CBER CMC BLA Resubmission Review Memorandum

BLA STN 125706

Remestemcel-L-rknd

1. **BLA#:** STN 125706; Complete Response submitted in 125706/0.65, SN0065

Table 7 - Hold Times for Remestemcel-L Reagent and In-Process Sterility Samples

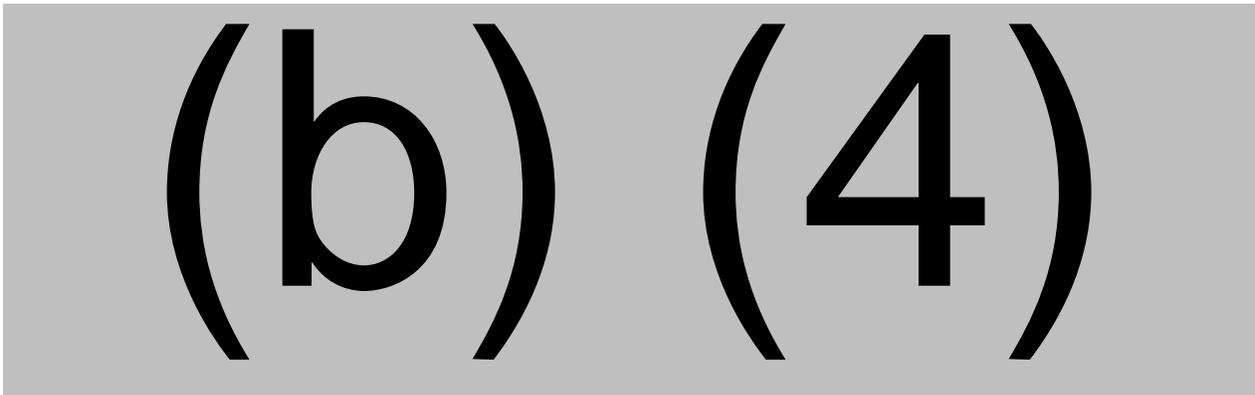
Reviewer Comments:
